TECHNICAL BULLETIN

Adjustable Shock Option used with BC310 or BC320 Cylinders

9900-9162_00 1/23/02

BC310 Cylinders

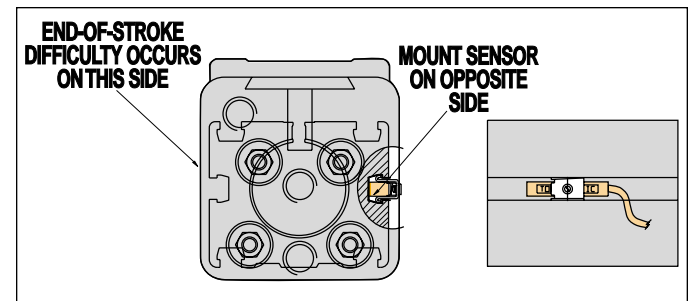
When using the adjustable shock option (AD2, AH2 or AL2) on both ends of either a BC310 or BC320 cylinder, there may be difficulty in the unit's ability to sense the "full end-of-stroke" with magnetic sensors.

On these two sizes of cylinders, the magnet is located "off center" on the piston. This causes the magnetic field used to activate the sensor to be off center as well. When the piston moves to one "full end-of-stroke" location, the magnetic field used to activate the sensor may overlap the shock absorber mounting hardware. This may result in an inability to position the sensor properly at the edge of the magnetic field. This condition will be present at one "full end-of-stroke" location only.

The piston has been fitted with two magnets, each on opposite sides of the piston. Install the sensor in the cylinder "T" slot on the opposing side of the cylinder. The magnet on that side will activate the newly installed sensor and allow "full end-of-stroke" sensing capability.
